## PIC16C63A Rev. A Silicon Errata Sheet

The PIC16C63A (Rev. A) parts you have received conform functionally to the Device Data Sheet (DS30605A), except for the anomalies described below.

**FIGURE 1:  $\overline{\text{MCLR}}$  EXTERNAL CIRCUIT**

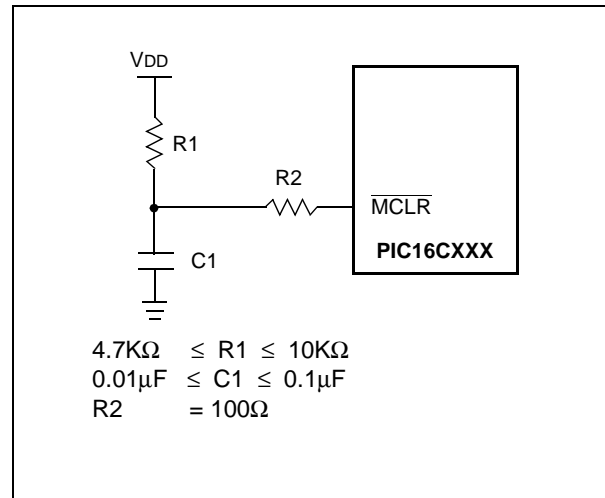
The minimum specification for the  $\overline{\text{MCLR}}$  must be met in order to RESET the PIC16CXXX. If a  $\overline{\text{MCLR}}$  pulse occurs that is less than the minimum specification (parameter #30), improper device operation can occur.

If the minimum specification cannot be met, then an external circuit must be used to insure that any pulse width less than the specification will be filtered before it reaches the  $\overline{\text{MCLR}}$  pin.

A possible circuit is shown in Figure 1. Proper design validation needs to be done to ensure desired operation over the applications operating conditions

**Figure 2: Wake-up from Sleep**

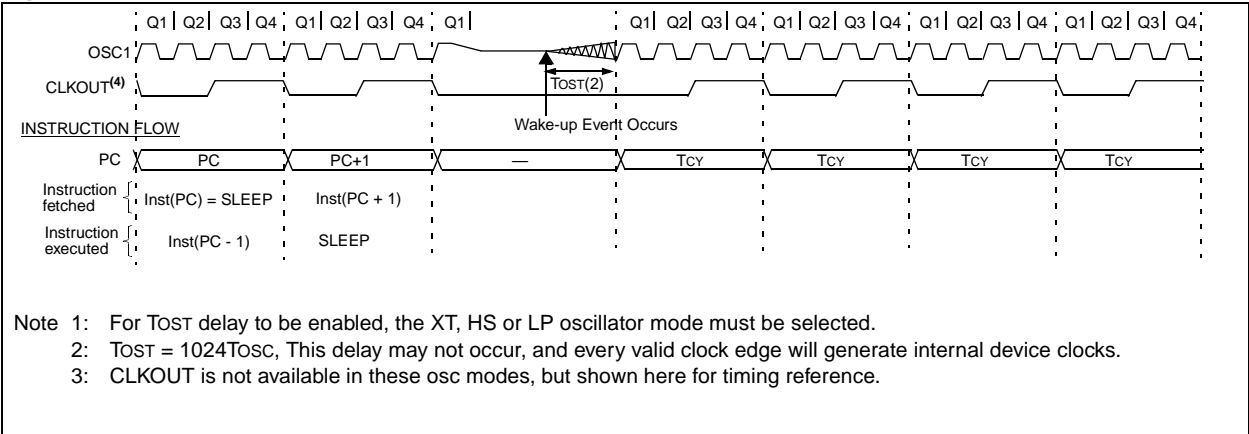
The Oscillator Start-up Timer (TOST) delay may not occur when the device wakes-up from sleep.

Figure 2 shows the start-up of the crystal after the event that causes the device to wake up from sleep mode (as specified in device data sheet). The start-up time (TOST) may not occur.

In applications where time based measurements are started immediately after wake-up from sleep, the suggested work around should be implemented.

After the SLEEP instruction, do a software delay of 256 Tcy (same as 1024 TOSC). At the Reset and Interrupt vector addresses, test to see if the device woke from sleep (the  $\overline{\text{TO}}$  and  $\overline{\text{PD}}$  bits), and if the device did wake from sleep, ensure that the total cycle delay is 256 Tcy.

**Figure 3: PIC16CXXX Voltage-Frequency Graph**

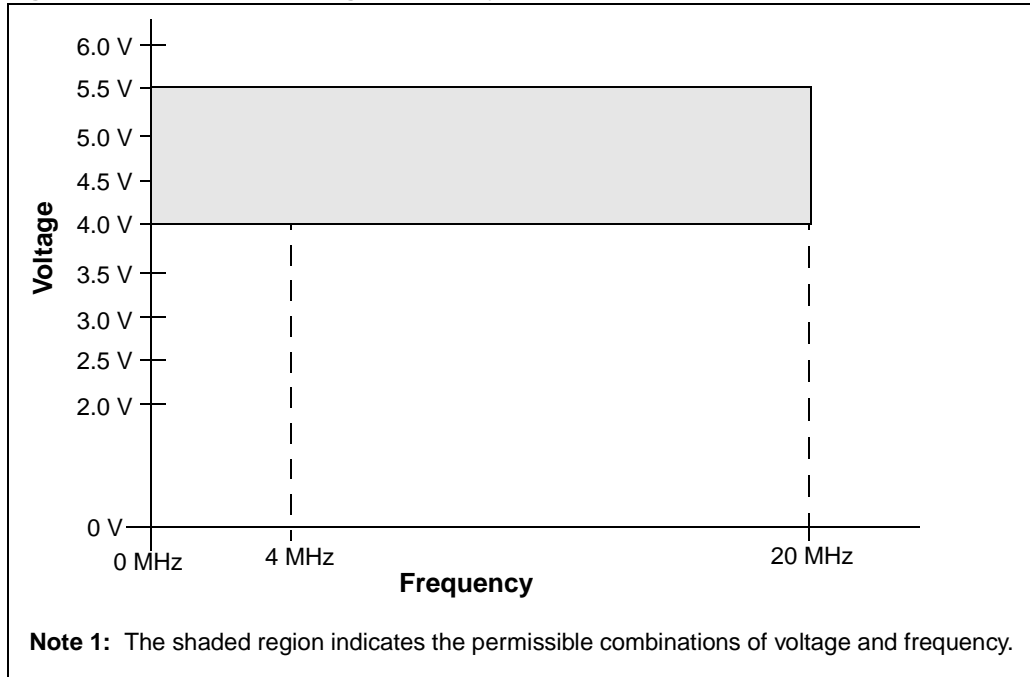
- Figure 3 and Figure 4 are additions to the data sheet to show the area of operation. These figures replace the Cross Reference of Device Specs for Oscillator Modes Table in the Electrical Specification section.

Figure 3 shows the voltage vs. frequency operation for the PIC16CXXX devices. Devices marked with a "-04" operate up to 4 MHz, while devices marked with a "-20" operate up to 20 MHz. The entire shaded region is the valid operating region.

**Figure 4: PIC16LCXXX Voltage-Frequency Graph**

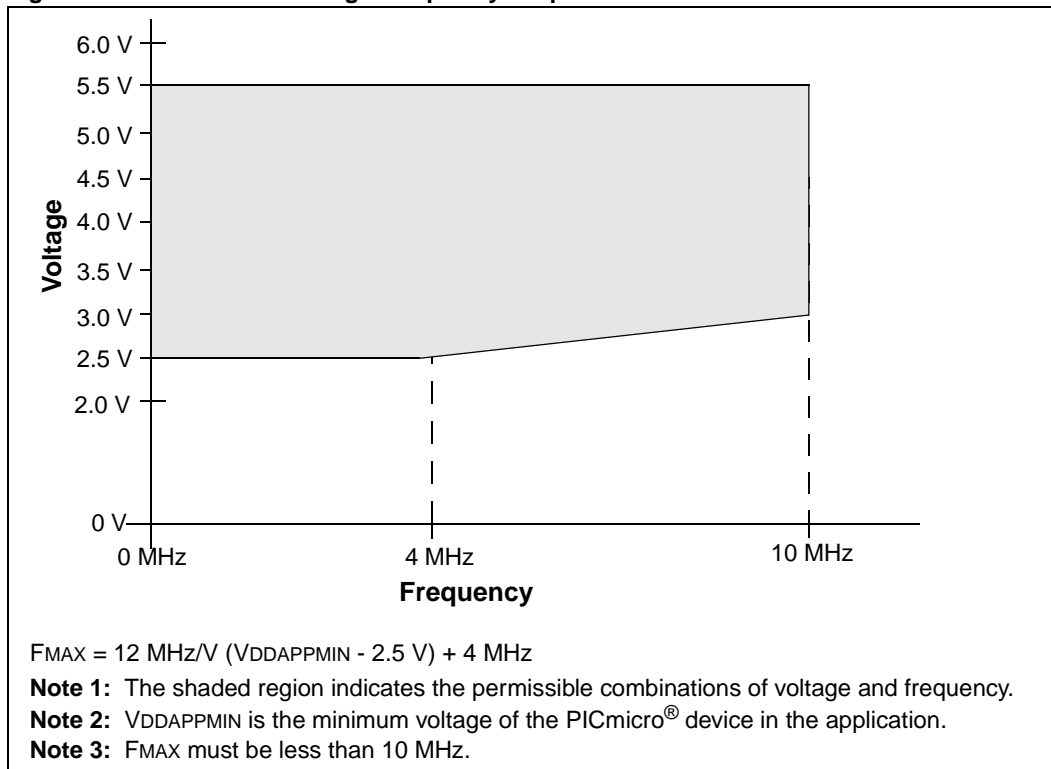
Figure 4 shows the voltage vs. frequency operation for the PIC16LCXXX devices. The devices marked with a "-04" operate up to 4 MHz at the minimum supplied voltage. The devices also operate at a higher frequency (10 MHz) and at a higher voltage (3V). The entire shaded region is the valid operating region.
